STATE OF NORTH CAROLINA
DEPARTMENT OF TRANSPORTATION

March 7, 2011

Subject: NCDOT Response to NC Division of Water Quality (NCDWQ) Letter, EB-4993

Subject: Proposed Neuse River Greenway in Johnston County, TIP No. EB-4993
DWQ Project # 20110175

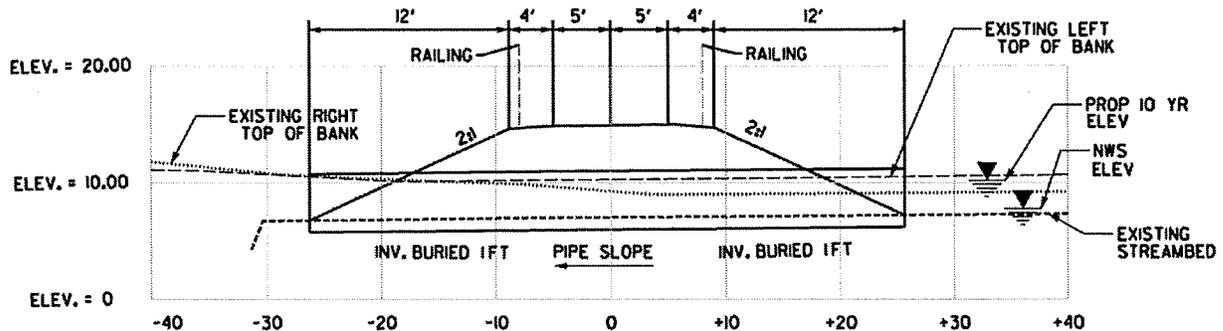
2. The amount of permanent stream impacts proposed in the application is 409 linear feet, divided among nine stream crossings. A standard paved greenway width is 10 feet of asphalt plus 2 feet of grass along each side. DOT proposes piped stream crossings ranging from 3-4 times as wide. Please clarify the need for such long culverts on this greenway at these numerous crossings.

During the design phase of this project, boardwalks spanning many of the smaller stream crossings were considered. However, it was determined that maintenance of the boardwalk by the Town of Clayton would be impractical, both from a cost standpoint and the fact that the trail has limited access. In addition, future maintenance of isolated portions of the trail itself would be in jeopardy, as pavers and surfacing equipment could not travel over the boardwalk crossings. Therefore, piping these crossings was chosen as a more viable option. To that end, NCDOT and the trail designer reviewed the proposed stream impacts in detail. It was determined that at two crossings, proposed rip rap stabilization above the ordinary high water mark had been included in the impact totals. These impacts were removed from the summary and the total stream impact was reduced to 394 linear feet.

The total stream impact of 409 linear feet from the previous submission is also a little misleading. The proposed trail is 10' wide asphalt. However, AASHTO requires a 2' wide shoulder on either side. Additionally, if the side slope is steep enough, AASHTO recommends a 4' wide shoulder with a railing (3' from edge of trail to railing, 1' behind railing). In an effort to reduce the total length of stream impact, the trail designer has used steep side slopes with railing at the jurisdictional stream crossings. This means the trail cross-section is actually 18' wide at these locations. Additionally, the jurisdictional streams in the project typically have relatively steep banks. If the jurisdictional stream has 6' banks, which is very common in this area, the stream impact is increased from the 16' of the trail cross-section by the total height times 2 (each

side of the trail) and times 2 again (2:1 max fill slope). At the 6' high stream bank, this works out to be:

6' high stream bank * 2 for each side of the trail * 2 for the max fill slope = 24'

The trail cross-section of 18' is then added to this 24' for the total stream impact at one location of 42'. This length of impact only gets worse if the crossing is skewed.
